**RE:                    PROPONENT'S COMMENTS IN RESPONSE TO SUBMISSIONS  
                         S75W APPLICATIONS FOR SHEPHERDS BAY – MP09\_0216 & MP09\_0219**

**DEPARTMENT OF PLANNING & INFRASTRUCTURE  
REQUEST FOR ADDITIONAL INFORMATION & KEY ISSUES**

**CONCEPT PLAN MP09\_0216 Mod 1**

## PROPONENT'S RESPONSE TO COUNCIL'S ISSUES – STAGE 1 PROJECT APPLICATION S75W (SHEPHERD'S BAY)

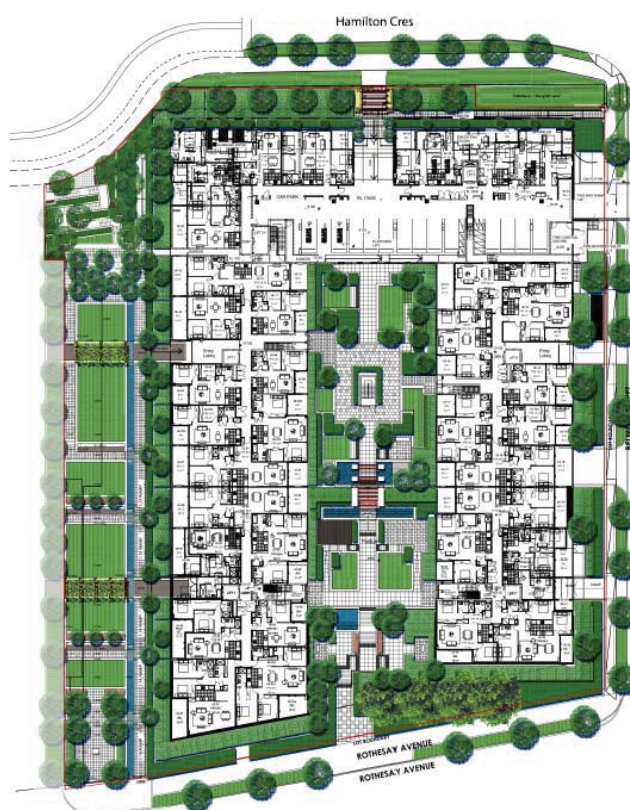
Should the Department require pedestrian access from Nancarrow Avenue via the pathway adjoining Stage 1 to Rothesay Avenue, a revised extent of works is proposed which includes the construction of stairs at the northern end of the foreshore link and the majority of the width of the foreshore link. The revised extent of works provides safe and convenient access with the Stage 2 construction processes including appropriate pedestrian safety measures. Refer to **Figure 3** below.

**Figure 3:** Revised Stage 1 Landscape Masterplan prepared by Place Design which identifies the revised Stage 1 construction boundaries including the pedestrian stairway access from Nancarrow Avenue and the majority of the foreshore link. The remainder of the foreshore link (left) is to be provided following the Stage 1 works and in conjunction with the construction works for Stage 2 to the west.

**Figure 3:** Extract of the Lower Ground Floor Plan A-003/I demonstrating the multiple access points (identified in blue) to Apartments LG24 and LG25. The egress points / corridors are also identified in green. Access via the foreshore link has been clarified.

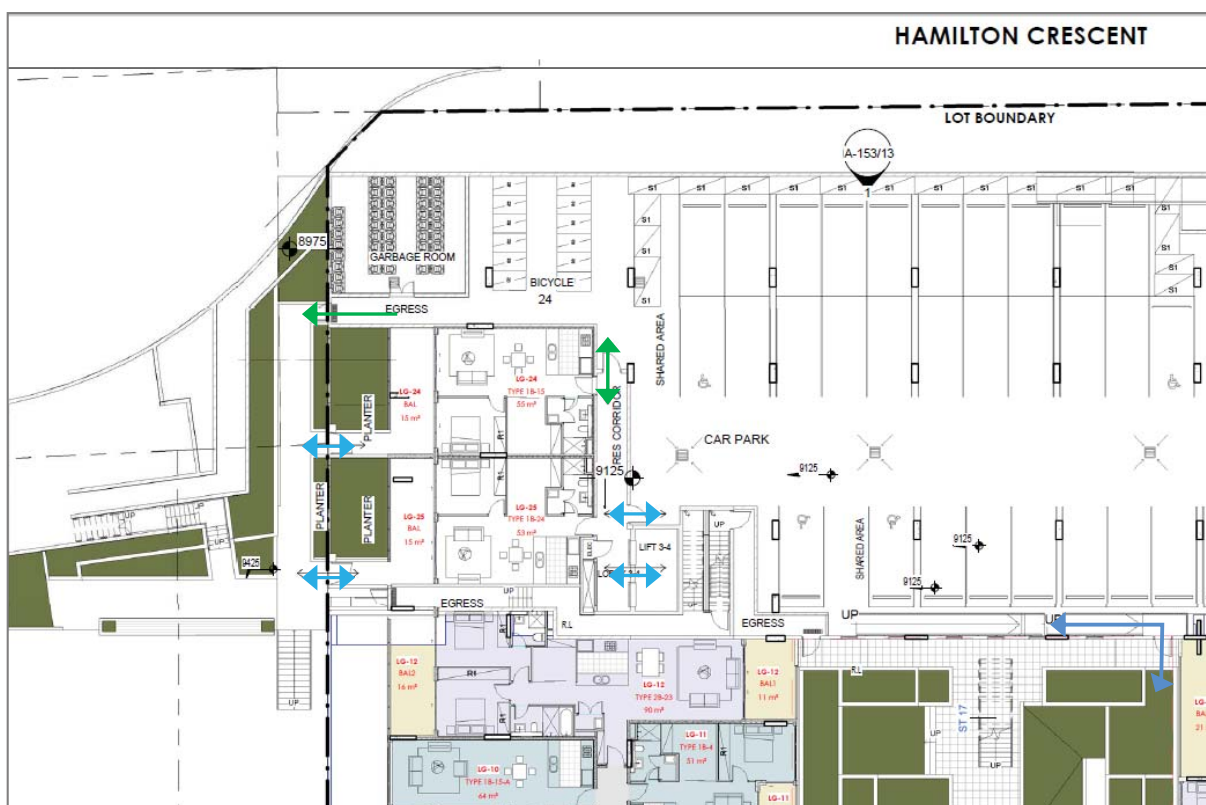
Apartments LG24 and LG25 have access from the internal car park which connects to the internal courtyard and the Foreshore Link. These apartments are also accessed via Lift 3-4 and Lobby 3-4. Further access is provided directly from the foreshore link, with the extract of the relevant plan updated in **Figure 3** below. This has been clarified in the attached amended plans. This design approach allows for multiple points of ingress and egress to suit the needs of the future occupants.

**Figure 4:** Extract of an indicative Planting Details Plan prepared by Place Design demonstrating that a minimum width of 2 metres of deep soil planting is sufficient to accommodate street trees. The proposal provides in excess of the minimum required width.

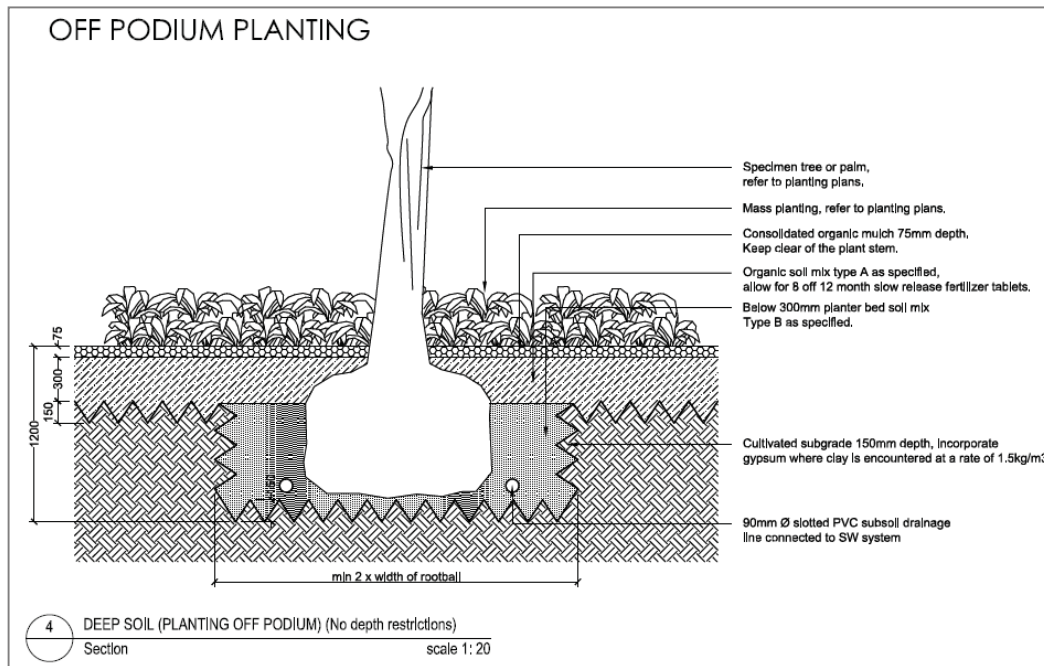
As demonstrated in **Figure 4** below, the deep soil area provided is in excess of the minimum 2m required to support the healthy growth of the street trees.
